The FHWA has received your request for approval of reevaluation seven for the I-26/126/20 (Carolina Crossroads) Environmental Impact Statement (Federal Project ID P027662). Project modifications analyzed within the reevaluation include,

Carolina Crossroads

NEPA RE-EVALUATION 7

Supporting Documentation

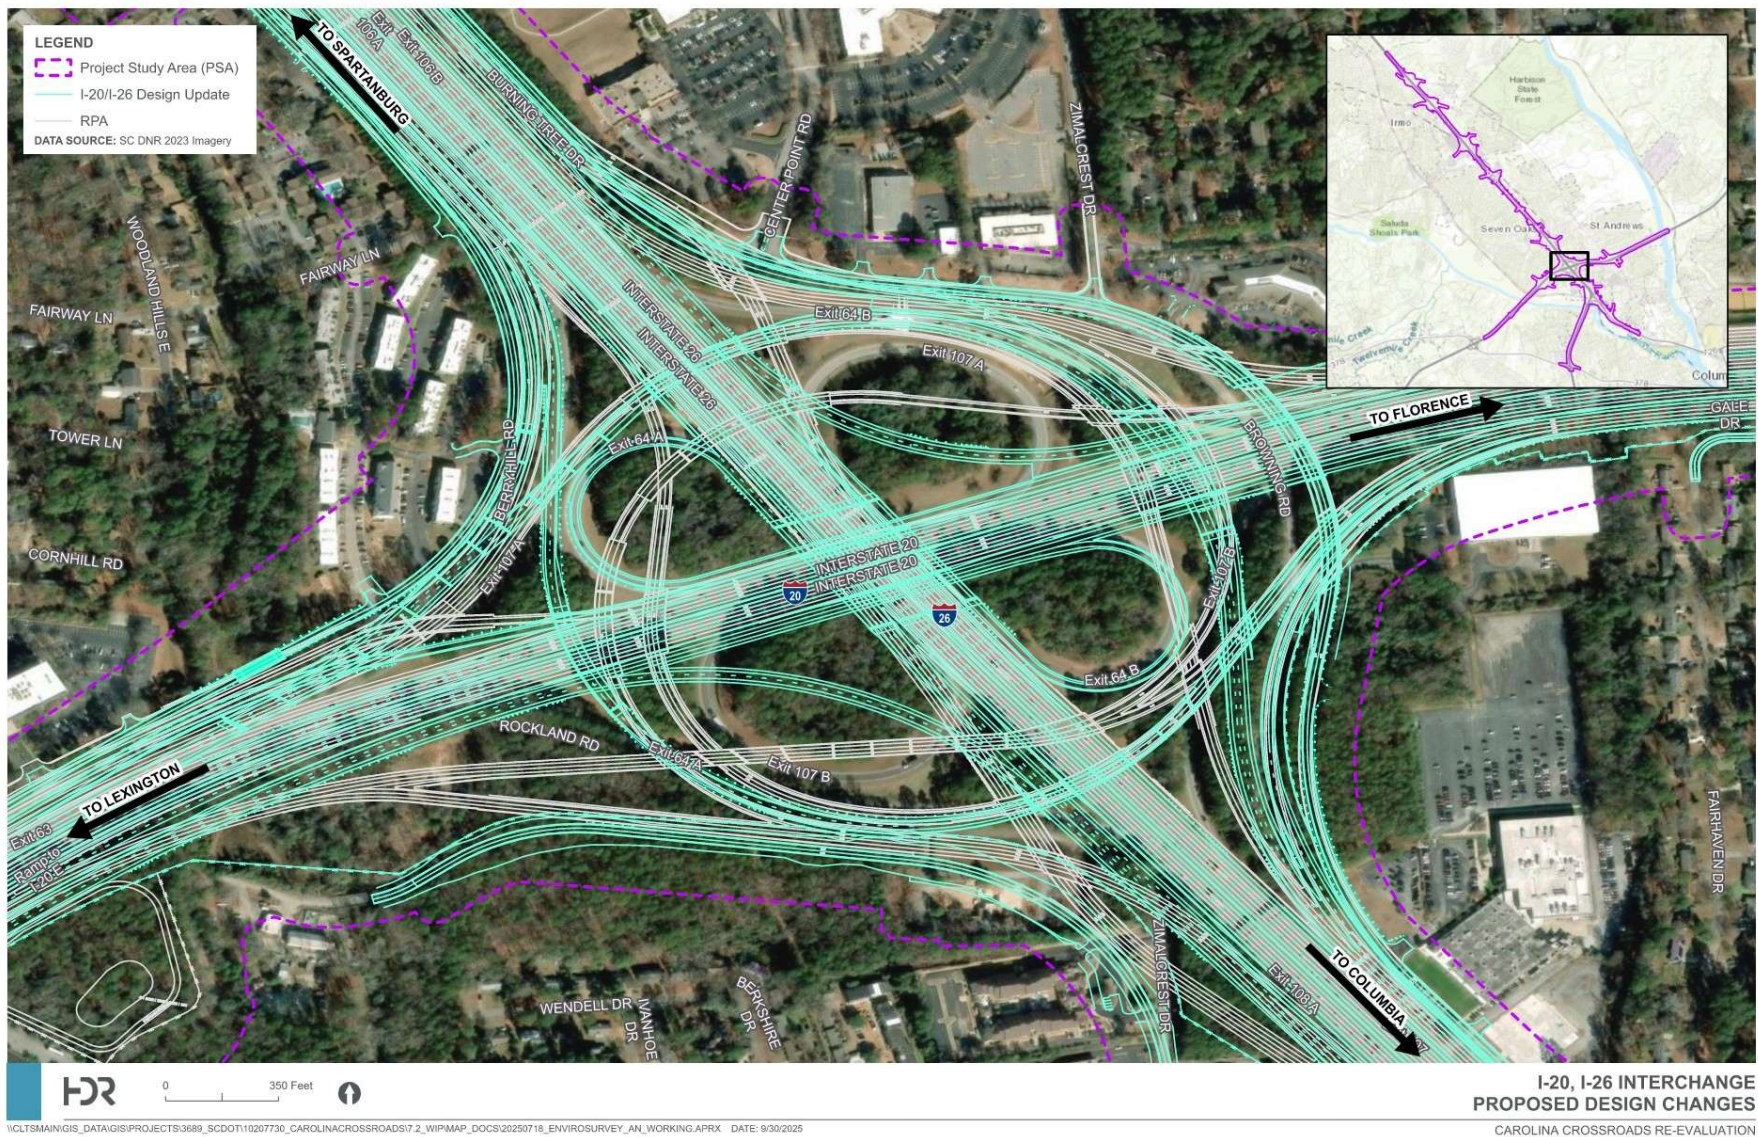
The RRPA originally proposed a turbine interchange design at the I-20 / I-26 system to system interchange. In efforts to improve constructability, reduce costs, and improve operations, the design was revised. The revised design proposes to reconstruct and improve two loop ramps, add collector-distributor (C-D) roads in both directions of I-26, and make improvements to ramps, and make improvements at the interchange at St Andrews Road, thereby improving traffic operations and safety (Figure 2). The C-D road implementation relocates merges, diverges, and weaves off the mainline interstate to improve operations and safety of the mainline. These design changes have been documented in an Interchange Modification Report (IMR) update that is currently under review at FHWA Headquarters.

The St. Andrews Road interchange in the RRPA was a single point urban interchange and has been revised to a partial cloverleaf interchange similar to the existing interchange but with tie-ins to the proposed I-26 C-D roads. This revision improves operations on St. Andrews Road and supports the design of the proposed I-20/I-26 interchange.

The revised design is within the previous project study area (PSA) and right-of-way at adjacent properties have already been acquired. In the northwest quadrant of the interchange, Berryhill Road and multiple system interchange ramps were shifted closer to the adjacent noise receivers, and the elevation of an interstate ramp was raised. As a result of these design changes, the traffic noise analysis was updated to assess any changes in noise impacts or noise abatement in Noise Sensitive Area (NSA) K. While impacted noise receivers did increase slightly in NSA K (+7 receivers), a reassessment of Noise Barrier K still found that these barriers were not reasonable/feasible. See attached noise memo in Appendix A.

Figure 4. Fernandina Road realignment and bridge over Stoop Creek

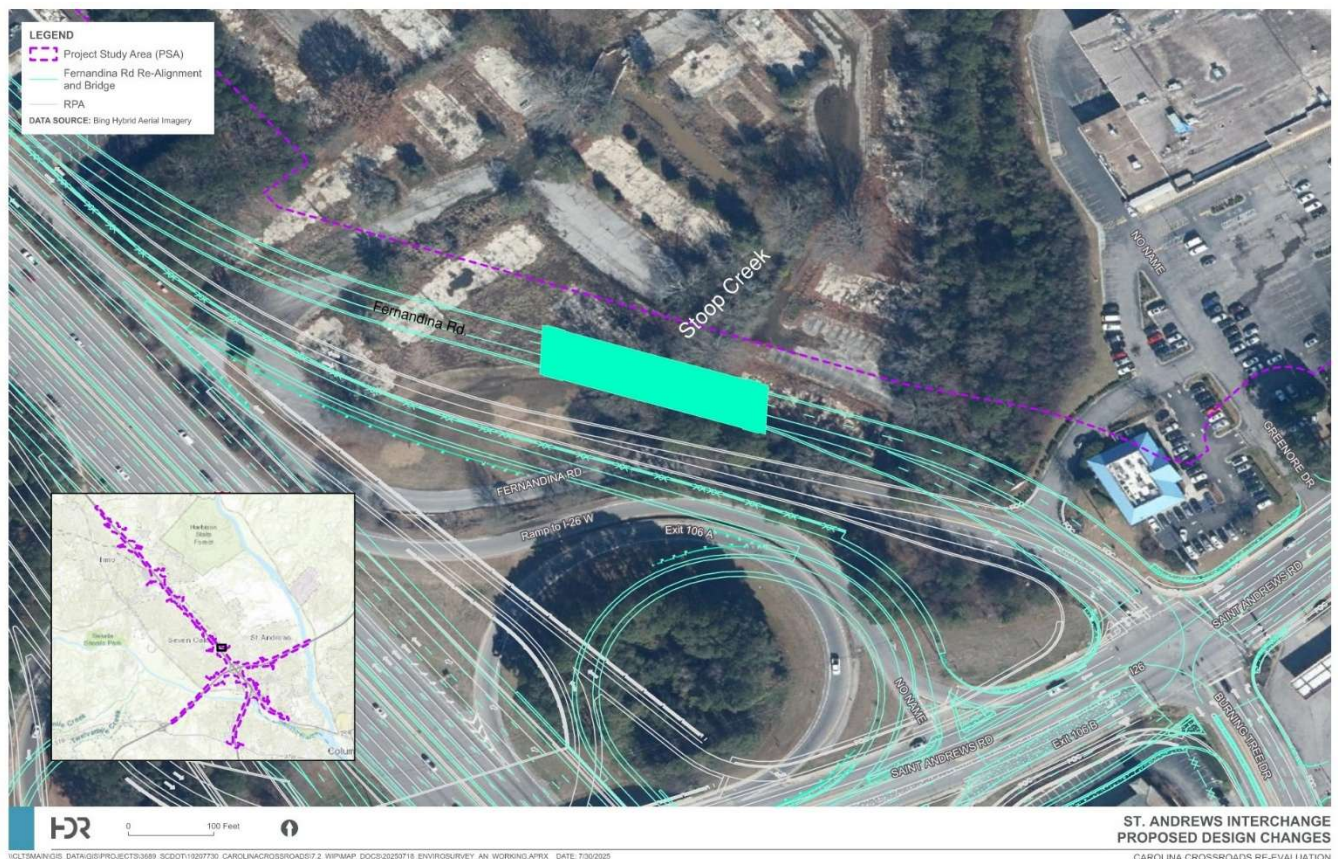
In the RRPA, Fernandina Road would remain in its current location and the culvert over Stoop Creek would be replaced with a new culvert. Based on additional hydraulic studies, the updated design proposes to replace the existing culvert with a bridge. To accomplish this, Fernandina Road would be realigned slightly to the north. See Figure 4.

The new bridge will allow for a “no rise” condition on Stoop Creek per FEMA requirements. This is a risk mitigation strategy for the overall project that will allow improvements in future construction phases to improve additional culverts on Stoop Creek (under I-26 and I-20) at separate times without impacting flooding conditions in the area, reducing design and regulatory risk. The bridge allows Fernandina Road to be offset further from the I-26/St. Andrews Road interchange, which further reduces the risk of design inter-phase and improves constructability of future phases.

Figure 5. Berryhill Road/Woodland Hills Road Intersection Realignment

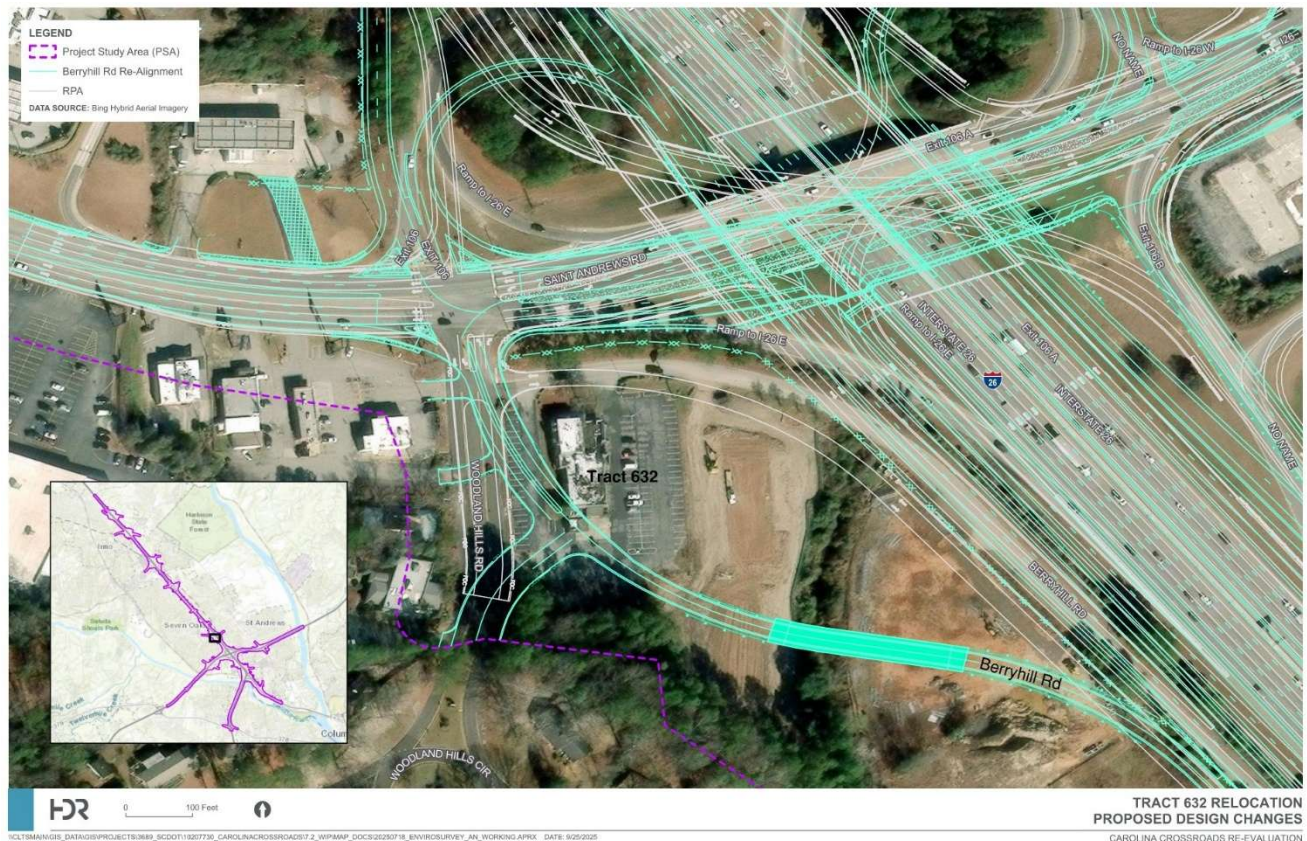
The RRPA did not make any adjustments to the alignment of Berryhill Road or its intersection with St. Andrews Road. A proposed design was developed which realigned Berryhill Road to intersect directly with St. Andrews Road. Woodland Hills Road would be realigned to tie into Berryhill Road approximately 350 feet prior to the intersection with St. Andrews Road to better meet design standards. The realignment would move the Woodlands Hill Road intersection approximately 350 feet further away from the St. Andrews Road intersection, thereby increasing the intersection spacing and simplifying turning movements at the two intersections improving safety. In addition, the relocated alignment will accommodate a bridge crossing of Stoop Creek and provide more room for utility relocations, while improving operations of the Berryhill Rd/Woodland Hills Road and St. Andrews Road intersections (Figure 5).

All areas of the realignment of Berryhill Rd/ Woodland Hill Road fall within the previously surveyed PSA, which has been surveyed, and impacts have been assessed in the ROD and/or previous re-evaluations. This design change would cause one additional business relocation, the Tokyo Buffet restaurant (Tract 632). Taken together with the above decrease at Harbison, there is a net decrease in relocations of two (2). Total business relocations for the overall project were 44 and are now 42.

Figure 7. Proposed park and ride location

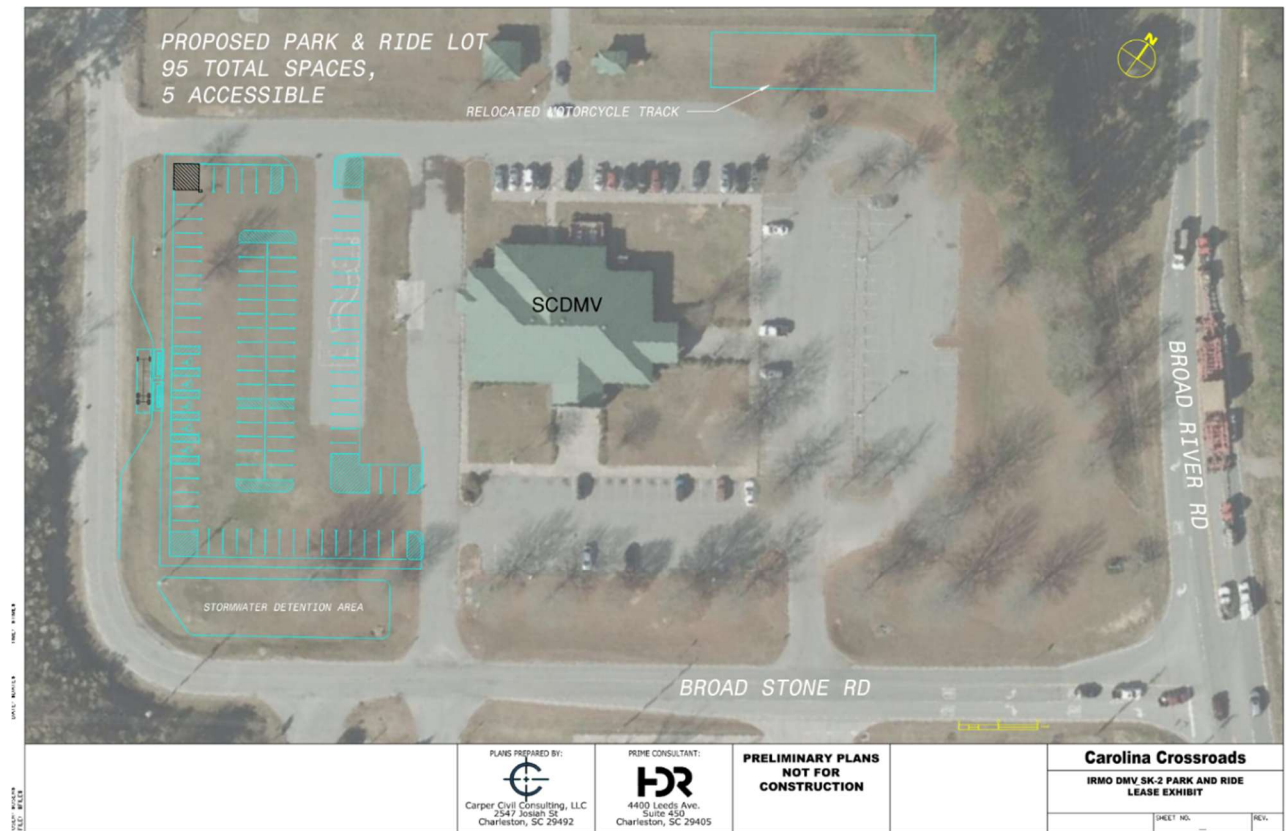
One park and ride site located at Exit 97 along I-26 was found to be feasible and agreements to lease a portion of the SC DMV parcel have been finalized. To meet the environmental commitment, SCDOT will make improvements to the site by extending the parking lot to add 95 parking spots and relocating the existing motorcycle track. SCDOT documented the park and ride analysis and selection process in a memo to FHWA in January 2025 – see Appendix G. For proposed site layout of the park and ride, see Figure 7.
